From: Kerry Legg
Sent: Wednesday, July 11, 2007 10:32 AM
To: Alan Farrant; Bernard Hejda; Scott Halbesma
Cc: Cliff Murray
Subject: New York - Roof top Evaporator Fires

Maintenance Directive

Subject: Interior Dome Lights and Evaporator hose on New Flyer 1997, 1998, 2000 and 2003 Articulated Buses

FIGURE # 6: SEPARATE THE CONNECTORS

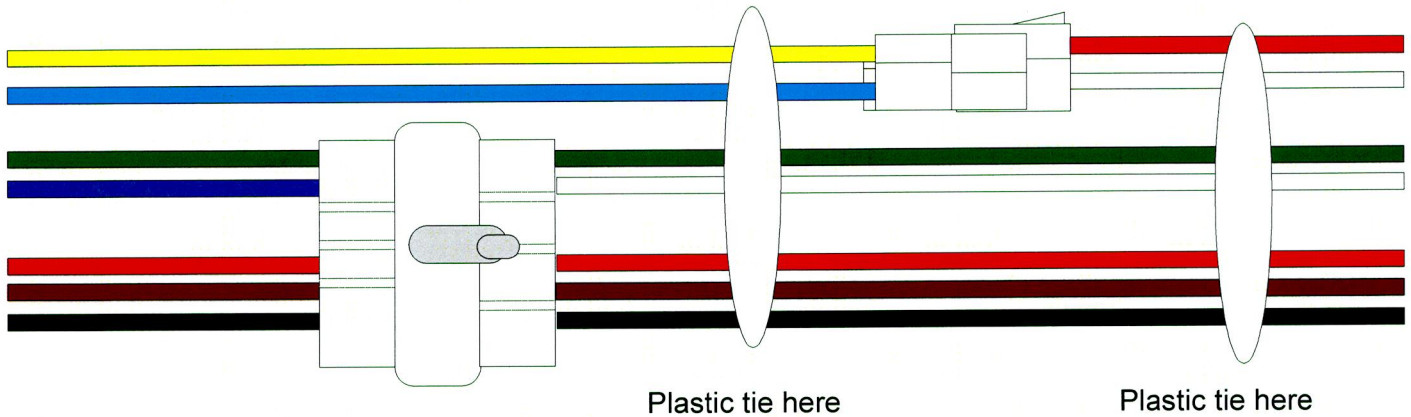
7. Reconnect all the connectors. Make sure no other terminals were pushed out of the connectors during this process. Secure the connectors with plastic ties, make sure to place them away from each other (see Figure # 6). **Reinstall the ballast and fluorescent lamp.**

FIGURE # 7: BEFORE REWORK

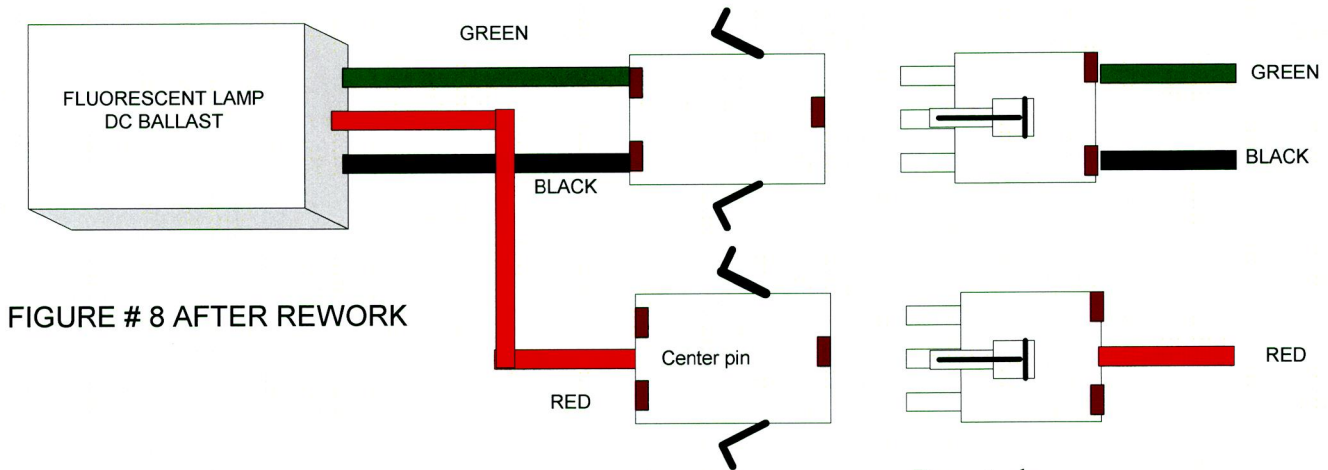
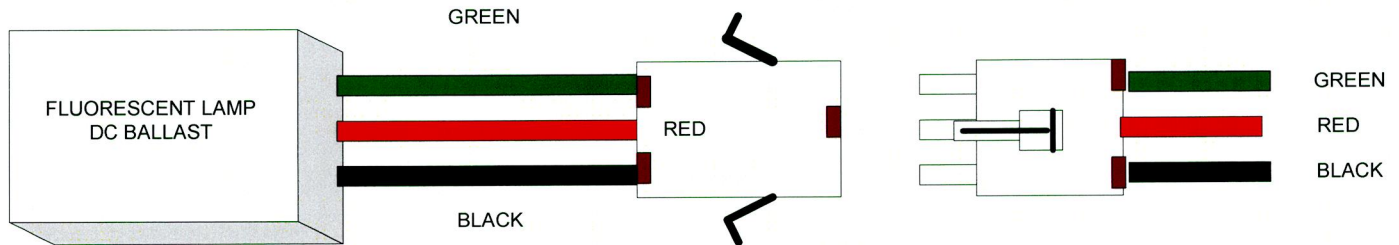
8. For the RH # 4, # 7 and LH # 4, #5 and # 8 dome lights, disconnect the Molex connector. Use the extraction tool (TA # 42-69-0080) to remove the Red wire from the plug (female) and from the receptacle (male) connectors (see Figure # 7).
9. Use the extraction tool to slightly open the male and female terminal locking tabs. Then, insert the terminals into the new connectors at the center (middle) slot as shown in Figure # 8.

FIGURE # 10 reroute the evaporator drain hose

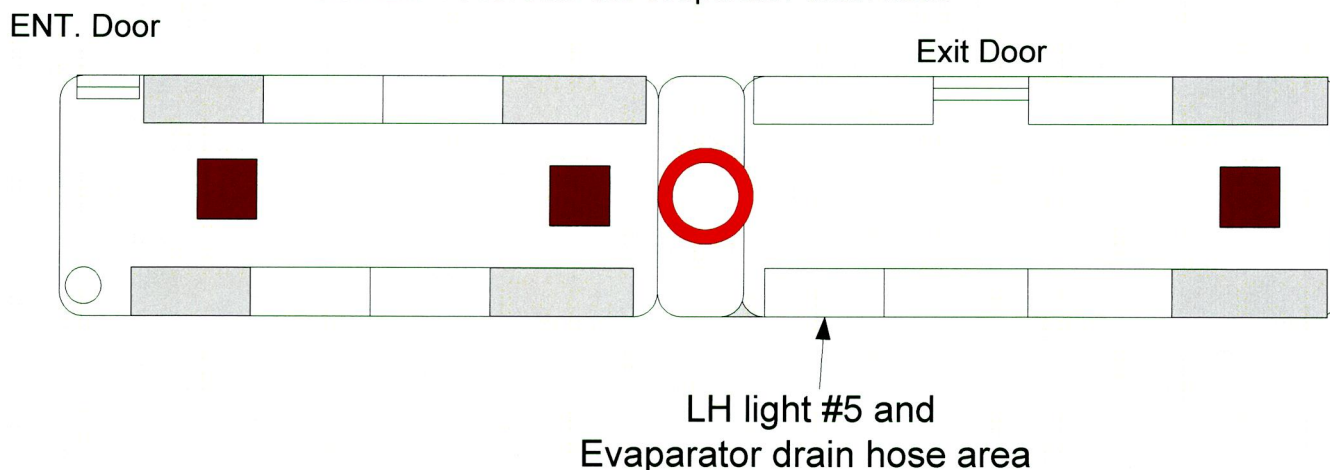
14. When performing the connector upgrade in the LH #5 light panel, locate the evaporator drain hose. **Remove the hose and plastic fitting at the top of the evaporator assembly.** See Figure #10, 11 and 12.

Figure #13: Install/secure the 45-degree elbow with reducer fitting attached. Elbow must face towards front of bus as shown.

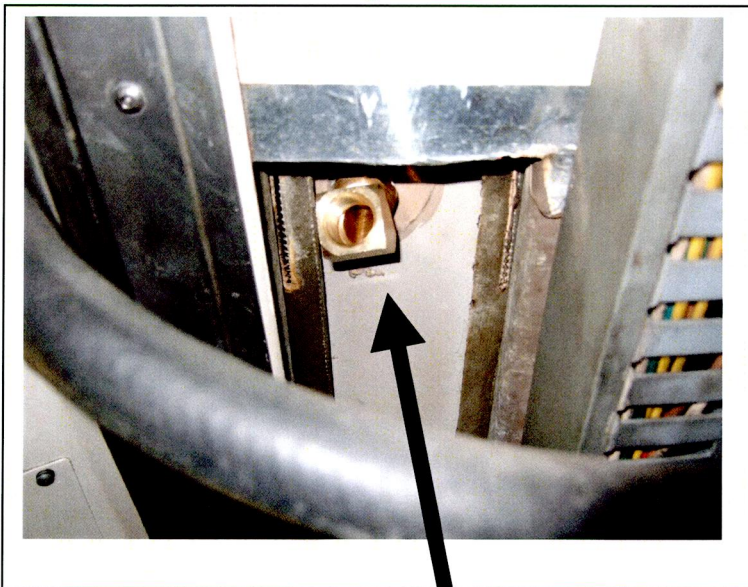
15. Install the 45 degree Elbow and the hose barb fitting. The fitting should be faced the front of the bus, as shown in the Figure #13 and 14.

Figure #15: Install the hose back onto the hose barb fitting and secure.

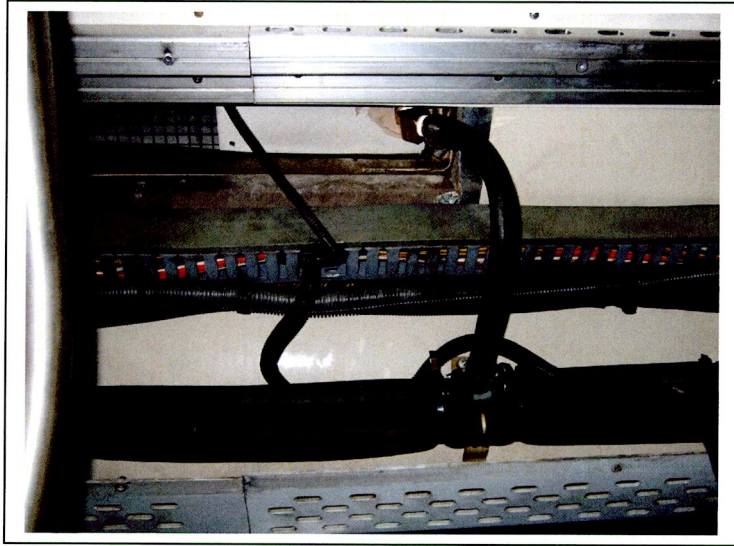
16. Install the same hose back onto the new hose barb fitting (if hose is damaged or chaffed replace this hose with TA # 00-00-0000, 3/4 heater hose). Secure with the original hose clamp. See Figure #15.
